## GENESEE COUNTY PLANNING BOARD REFERRALS NOTICE OF FINAL ACTION

**T-02-BAT-04-25**

**Site Plan Review and Area Variance to construct an 80 sq. ft. entryway to an existing industrial building.**

**4814 Ellicott Street Rd. (NYS Rt. 63), Batavia**

SITE PLAN, SITE PLAN DATA, FRONT  
ELEVATION

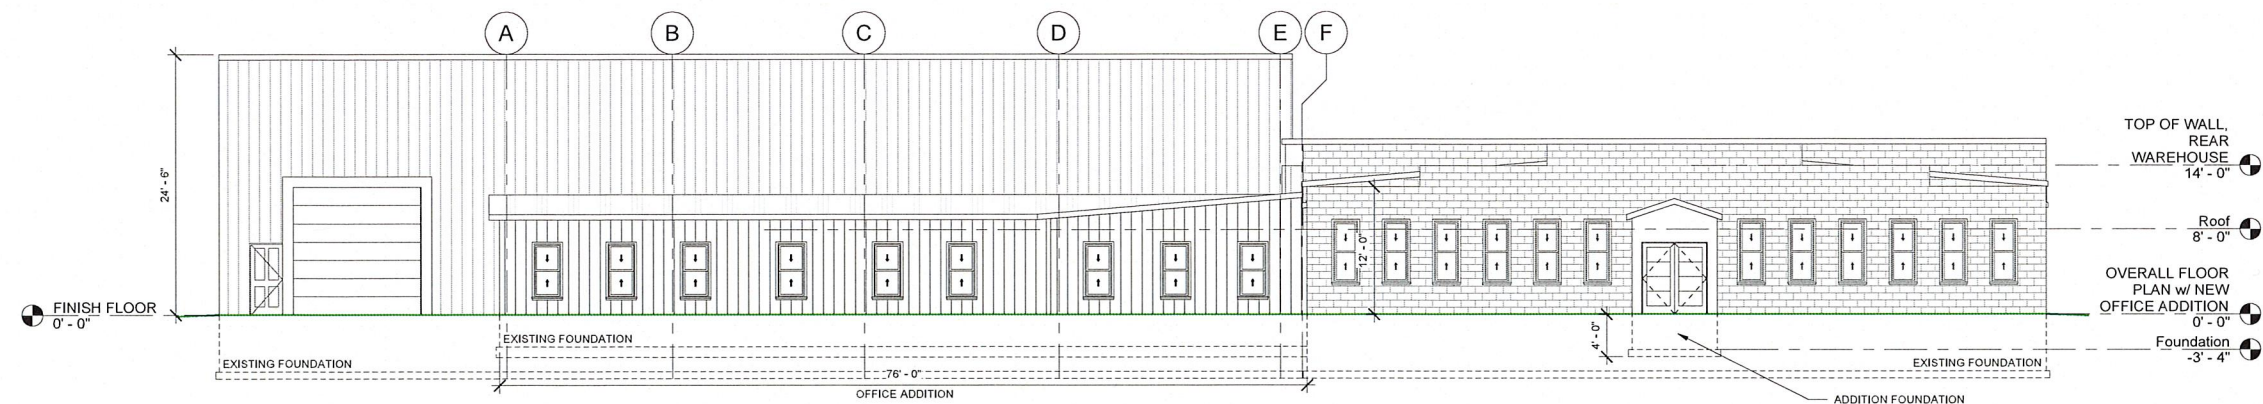
**Front Yard Setback**

**Minimum required: 50 ft.**

**Existing: Approx. 30 ft.**

**Proposed: Approx. 21.5 ft.**

**Given that the Town Planning Board has already approved the previous site plan with the lot dimensional deficiencies, the proposed office addition should pose no significant county-wide or inter-community impact.**

**APPROVAL**
